ADDRESS . : 642 PINEVALLEY LN
CONTRACTOR : CUMBERLAND HOMES INC
OWNER . . : SILVERADO HOMES, LLC #252
PARCEL . . : 03-9587-14- -0020- -11-
APPL NUMBER: 07-50018052 CP NEW RESIDENTIAL (SFD)
DIRECTIONS : CRESTVIEW ESTATES #252-27W LEFT ON
BUFFALO LAKES RD LEFT INTO S/D ON
CRESTHAVEN DR LEFT ON PINEVALLEY LN LOT
RT. JD

PERMIT: CPSF 00 CP * SFD

Re: J75394
Silverado Homes / Lot 252 Crestview

JOB	TRUSS	Truss Type	Qty	Ply	Silverdale Homes / Lot 262 Crestview	E4420573
J75324	F1	FLOOR	6	1	Job Reference (optional)	
Contact Inc, PO Box 40404, D10-884-4787					7,023 Nov 9 2007 Mittek Industries, Inc. Thu Nov 15 14:28:58 2007 Page 1

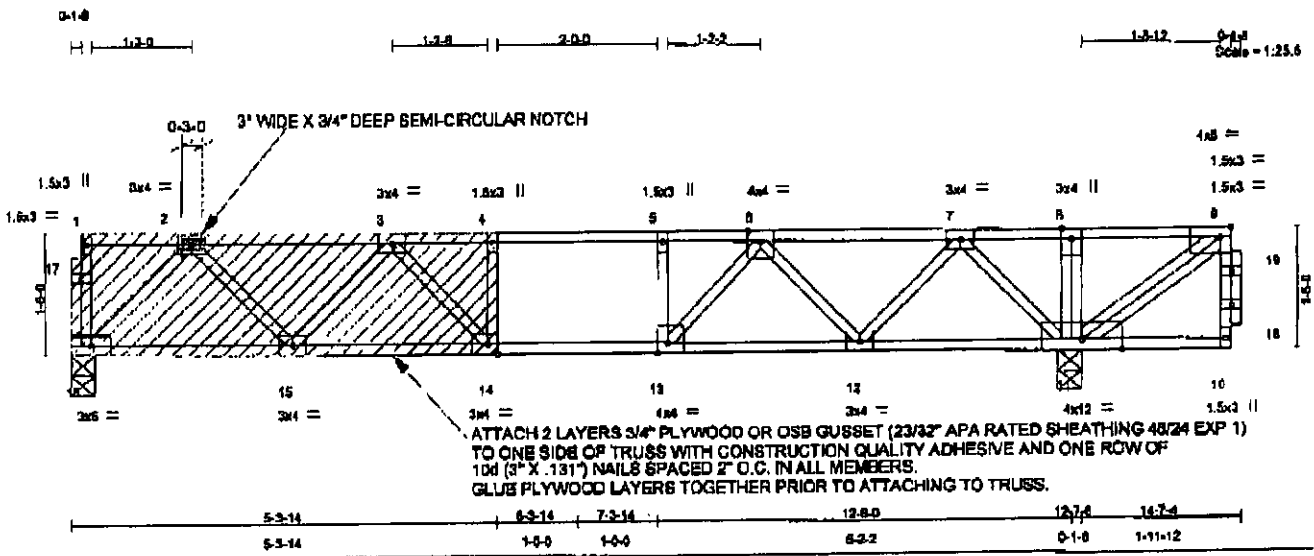
*Rec'd.
Letter on Truss Repair (F-4)
under table*
